February 17, 2025
File No. 20.0157080.00

Subject: Supplemental Site Investigation Work Plan
Oshkosh Defense Waukau Lot
359 West Waukau Avenue
Oshkosh, Wisconsin
BRRTS No. 02-71-587405

SUPPLEMENTAL SITE INVESTIGATION WORK PLAN
WAUKAU LOT

PROPOSED MONITORING WELL LOCATION

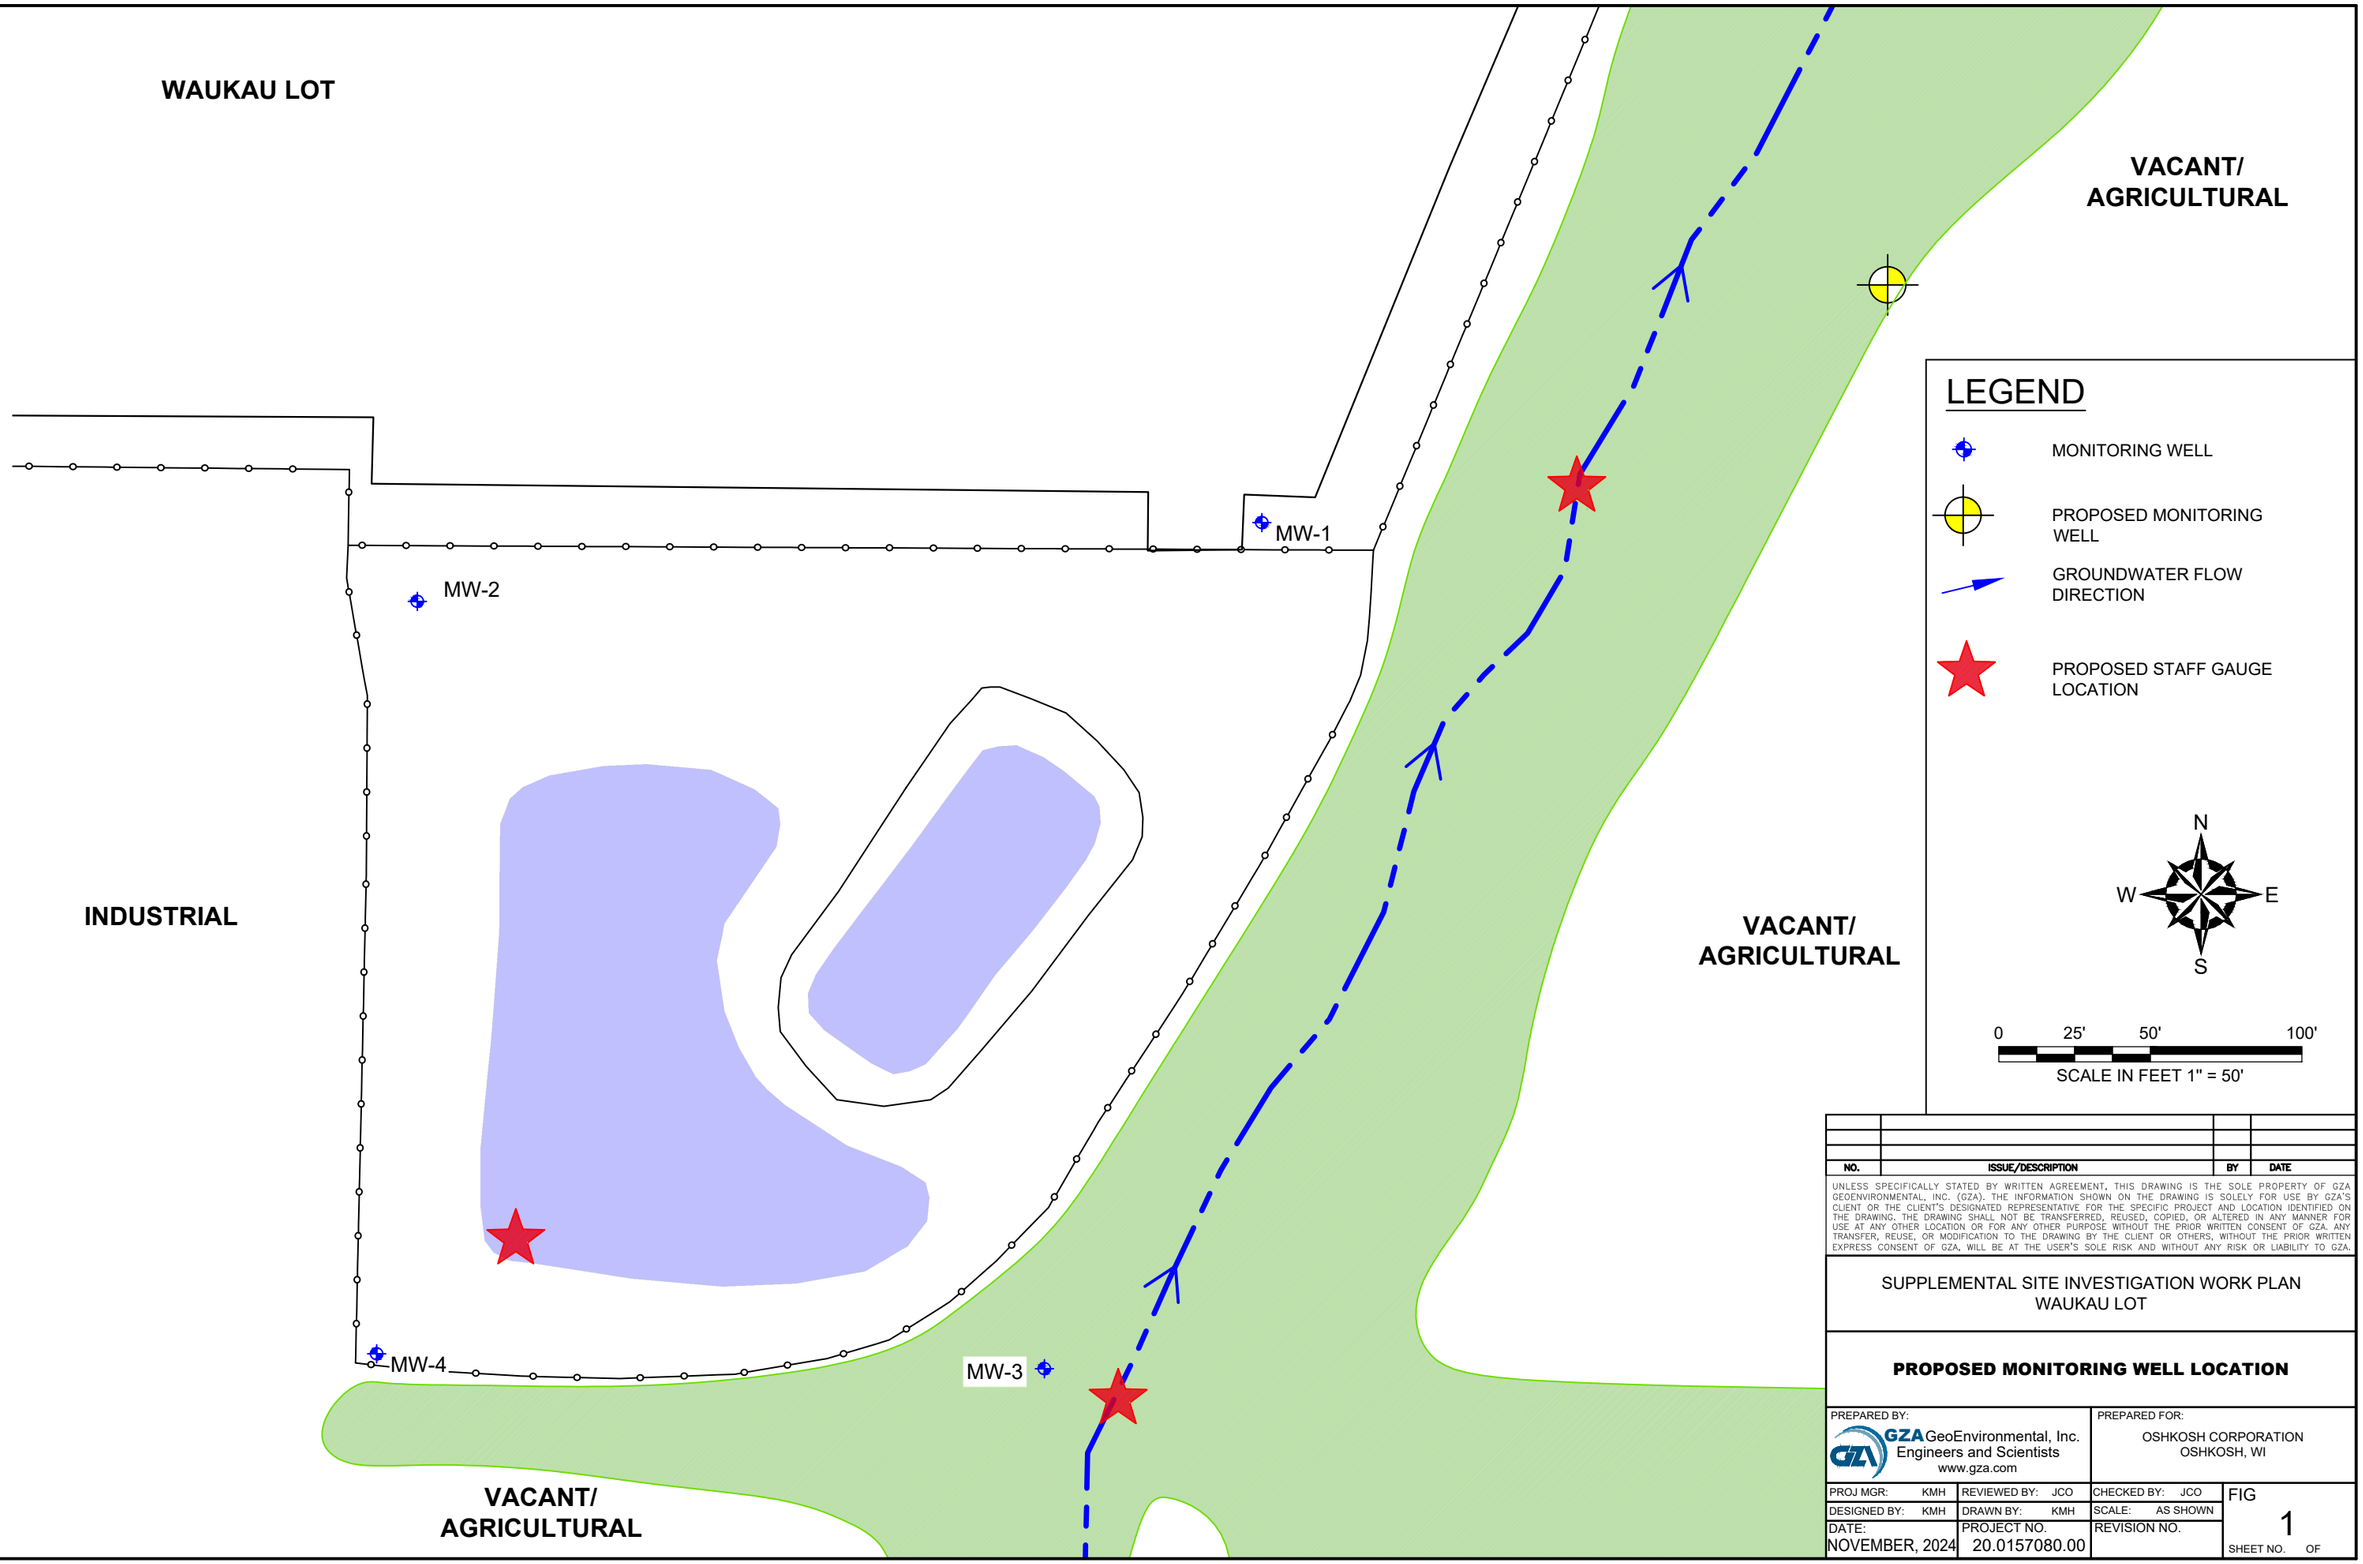
- A groundwater monitoring well is needed downgradient, east/northeast, of MW-1; and
- Evaluation of the stormwater pond as a source of residual surface/groundwater contamination.

- Installation of one Chapter NR 141-compliant groundwater monitoring well east/northeast of existing monitoring well MW-1, as shown on **Figure 1**. This well is proposed to be installed approximately 150 feet to the east, just beyond Gallups/Merritts Creek. Based on variations in groundwater and surface water elevations, it appears that groundwater discharge to the creek is seasonal, and underflow predominates.

- A comparison of the groundwater elevations collected from monitoring well MW-4 and the unlined pond indicate that the water in the pond is groundwater. Groundwater samples collected from monitoring well MW-4 indicate that there are regional PFAS concentrations migrating onto the Oshkosh property. To assist in understanding surface/groundwater interaction at the Site, a staff gauge will be installed in the natural pond to allow for measurement of the surface water elevation. The staff gauge will be installed near monitoring well MW-4, as shown on **Figure 1**.
